Wallerawang Battery Energy Storage System

Response to Submissions

May 2022

Figure 7-3: Proposed 2D strategic intersection design for construction

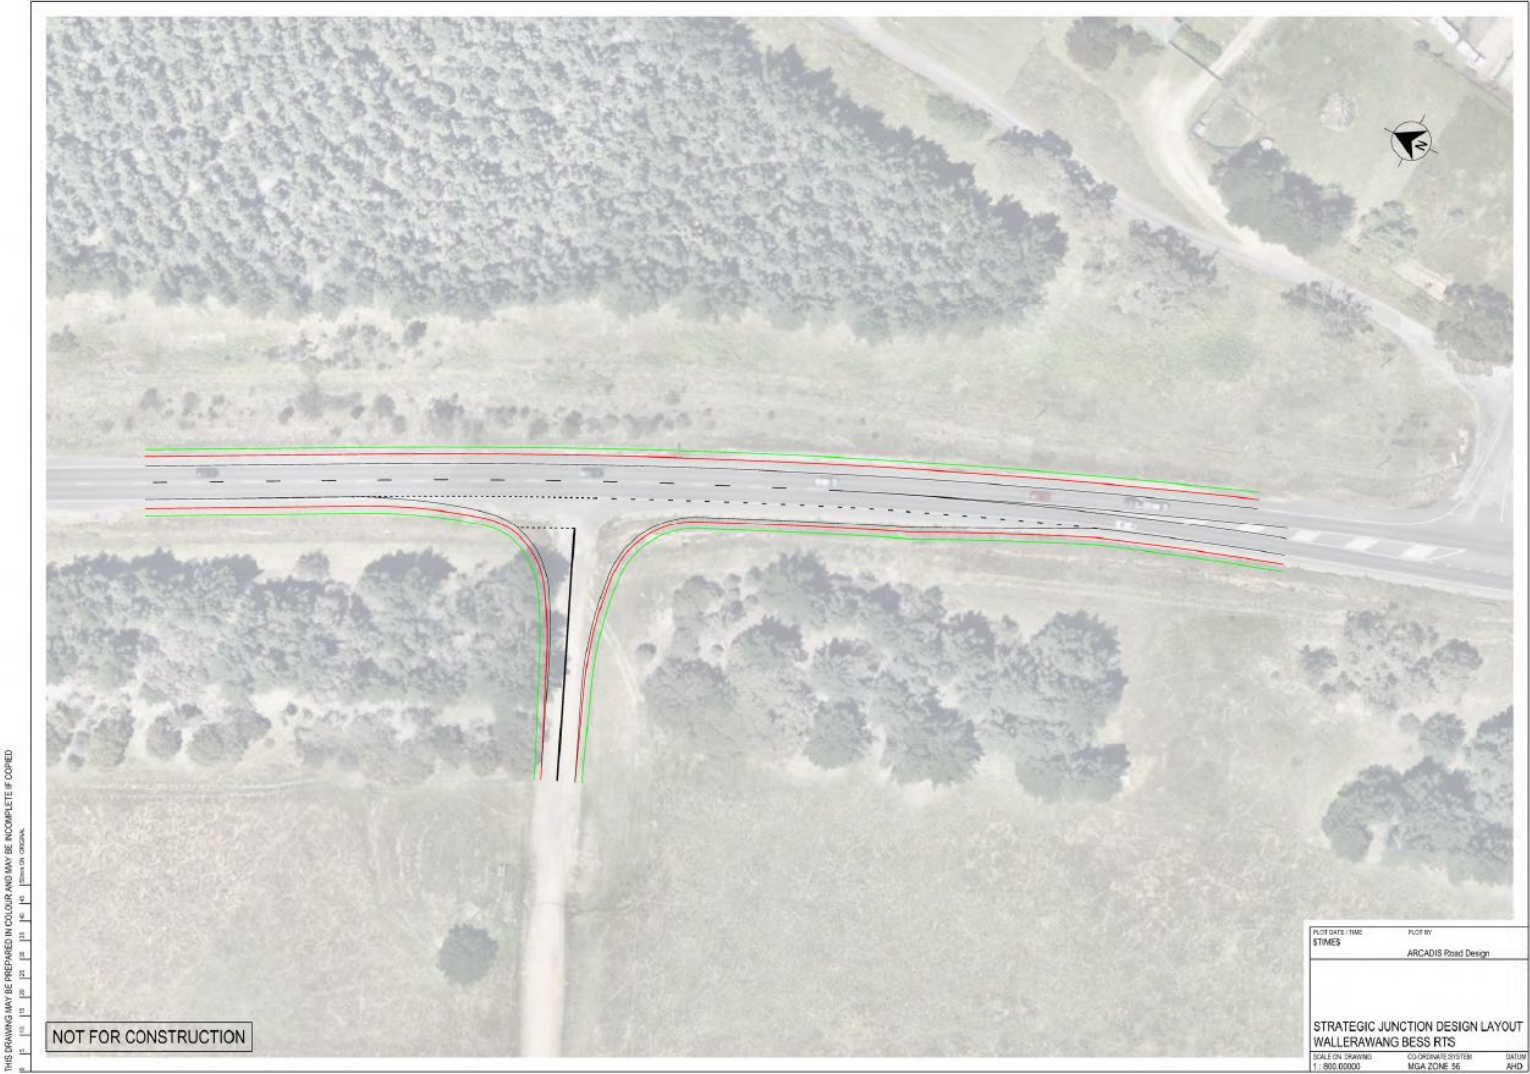
No.	Comment	Response	Reference
A7.1	<p>Safe Intersection Sight Distance</p> <p>Following a site visit TfNSW raises concern regarding available sight distance approaching the site from the south. Scaled plans are required to demonstrate sight distance is available at the proposed access to the Castlereagh Highway, a design speed of 110km/h needs to be adopted (refer to Table 3.2 of Austroads Guide to Road Design Part 4A).</p> <p>Sight distance diagrams need to be provided using an eye height of 1.1m and a vehicle height of 1.25m showing the sight distance available both horizontally and vertically in accordance with Fig 3.2 Austroads Guide to Road Design Part 4A.</p> <p>Where landscaping and/or fencing is proposed along the property boundary, the plan must demonstrate the landscaping and/or fencing will not compromise sight distance.</p>	<p>Arcadis has undertaken a Safe Intersection Sight Distance (SISD) assessment for the Project Site's proposed access point. The SISD assessment was based on the provisions of <i>Austroads Guide to Road Design - Part 4A: Unsignalised and Signalised Intersections</i>.</p> <p>Figure 4-5 of the revised TIA shows the concept through which the SISD was calculated, using an eye height of 1.1 m and a vehicle height of 1.25 m.</p> <p>Table 4-25 of the revised TIA details the calculated minimum SISD in both directions which is 309 m to the proposed access from the south and 280 m to the proposed access from the north. Based on a desktop assessment and as described in Section 4.1.3.6 of the revised TIA, it was concluded that sufficient SISD was available for the north to south movement along the Castlereagh Highway but that vegetation clearance would be required for the south to north approach along the Castlereagh Highway to achieve the minimum sight distance requirements for the SISD. The extent of vegetation clearance or maintenance would be determined during detailed design.</p> <p>Plant Community Type (PCT) 677 (<i>Black Gum grassy woodland of damp flats and drainage lines of the eastern Southern Tablelands; South Eastern Highlands Bioregion</i>) (PCT 677_moderate) was only recorded within the proposed EIS construction footprint for the temporary intersection. The</p>	<p>Table 4-25 of the revised TIA (Appendix B of this RtS)</p> <p>Section 4.1.3.6 of the revised TIA (Appendix B of this RtS)</p> <p>Figure 4-5 of the revised TIA (Appendix B of this RtS)</p> <p>Section 7.3 of this RtS</p>

No.	Comment	Response	Reference
		proposed 2D strategic intersection design (Figure 7-3) would result in a reduction from 0.24 ha to 0.01 ha of this vegetation type. The comparison of vegetation clearance required for the EIS and the 2D strategic intersection design is provided in Figure 7-4 and Table 7-2). An additional 0.09 ha of cleared exotic grassland and 0.01 ha of native/exotic roadside vegetation would be removed to accommodate the 2D strategic intersection design. This vegetation was assessed in the BDAR. This is further detailed in Section 7.3 of this RtS.	
A7.2	<p>Traffic Impact Assessment</p> <p>Section 3.2.7 suggests that most of the construction traffic will arrive from the south from Lithgow and Sydney. Construction movements are anticipated to include 200 light vehicle trips per day, up to 40 heavy vehicle trips per day and up to 36 OSOM movements across the construction period which is expected to take 12-24 months to complete.</p> <p>Section 3.4.1 suggests all construction movements will be outside of the AM/PM peak for Castlereagh Highway. There is minimal detail as to how this will be managed and enforced.</p> <p>TfNSW requires a worst-case scenario to be provided in terms of traffic impacts on the surrounding road network.</p>	<p>Arcadis has undertaken a sensitivity analysis, using the peak hours between 6am and 7am provided by TfNSW. The workforce required for the construction stages would be drawn from the surrounding population including Wallerawang, Lidsdale, Cullen Bullen, Capertee in the north, Bathurst in the west and Lithgow in the south. It is envisaged that the bulk (95%) of the workforce will come from the south and west and 5% from the north consistent with population distribution. Table 3-2 of the TIA shows assumptions for the origins and destinations of the construction traffic generated.</p> <p>As detailed in the TIA (Appendix B), to minimise the impact of construction traffic at the access intersection during the 6am to 7am period all traffic entering the site will be mandated to come from the south (i.e. northbound on the Castlereagh Highway). To achieve this, it is proposed that these vehicles would travel via Main Street and Barton Avenue through the town of Wallerawang, to access the site (refer to Figure 5-10). This results in a total of 100 trips per hour coming from the south to the access intersection. A maximum additional travel time of 10 minutes is expected with the proposed alternative</p>	<p>Section 5.1.5 of the revised TIA (Appendix B of this RtS)</p> <p>Table 3-2 of the revised TIA (Appendix B of this RtS)</p> <p>Table 8-1 Mitigation measure</p> <ul style="list-style-type: none"> NEW TA2
